# Groundwater Application Review Summary Form

Application # G- 19157

GW Reviewer Phillip I. Marcy Date Review Completed: 02/03/2023

Water-Level Measurements in Nearby Wells

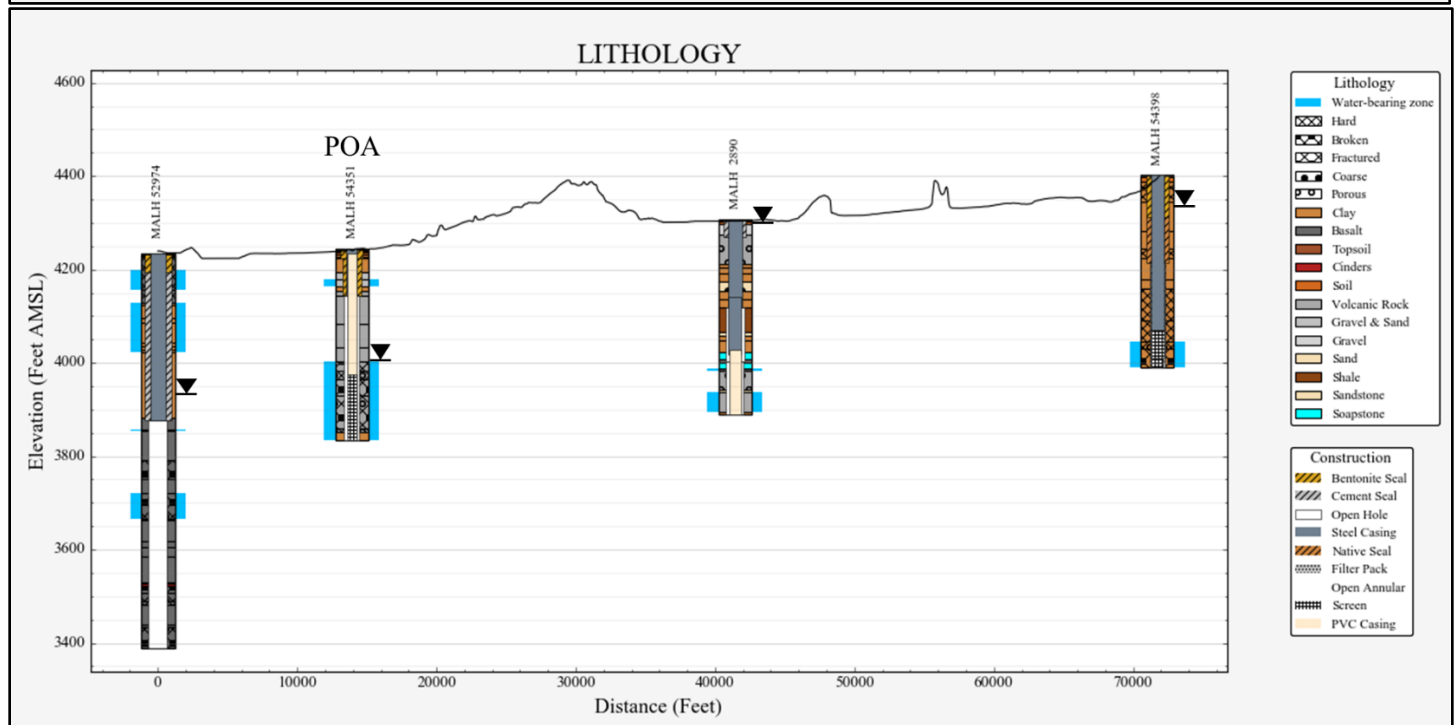
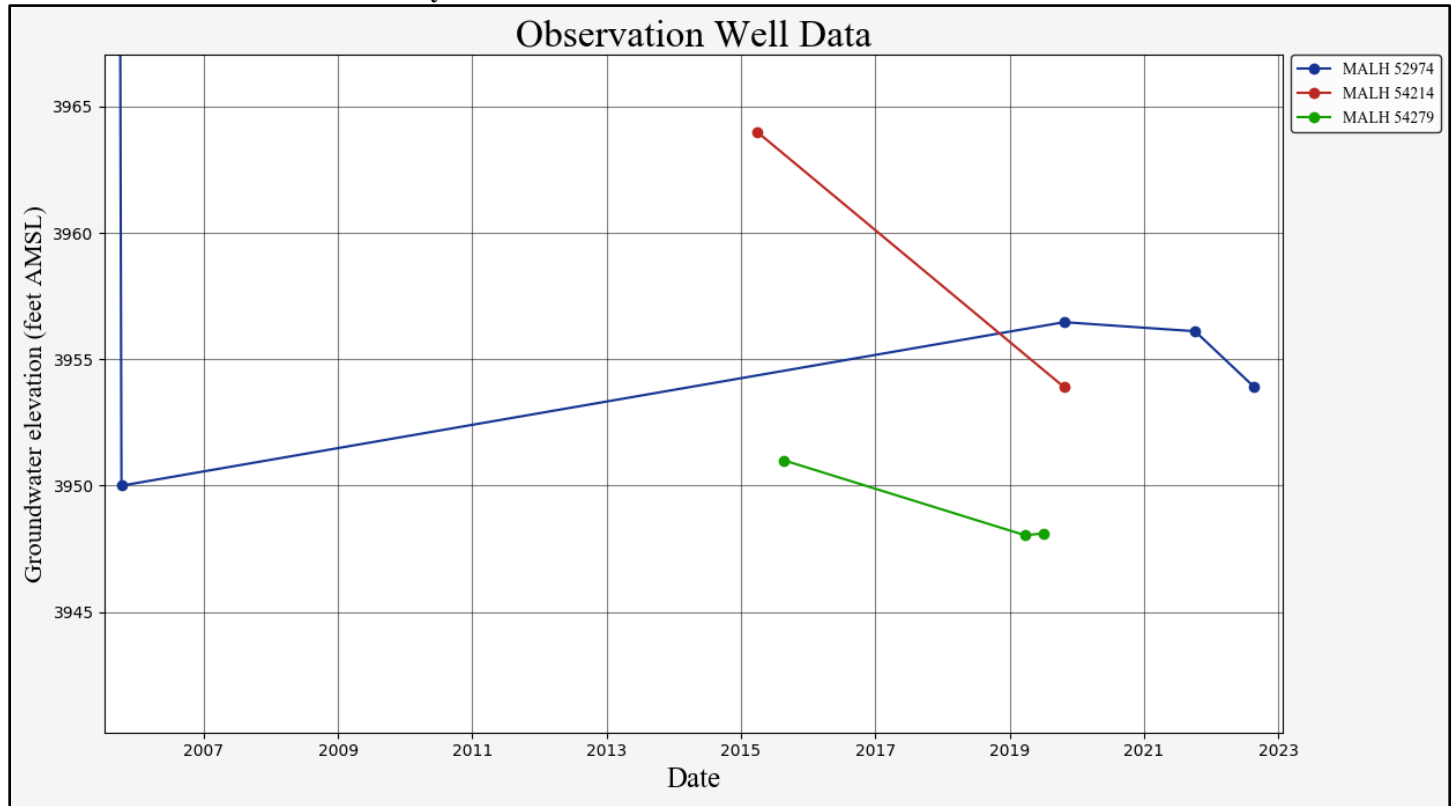
Deep wells producing from volcanic rock in the Danner Valley exhibit little to no confined pressure, as opposed to those producing from similar depths in Jordan Valley to the east, in which confining pressure brings static water levels to near land surface. Water level records in the Danner Valley deep aquifer (top) do not conclusively display excessive declines upon review of available data.
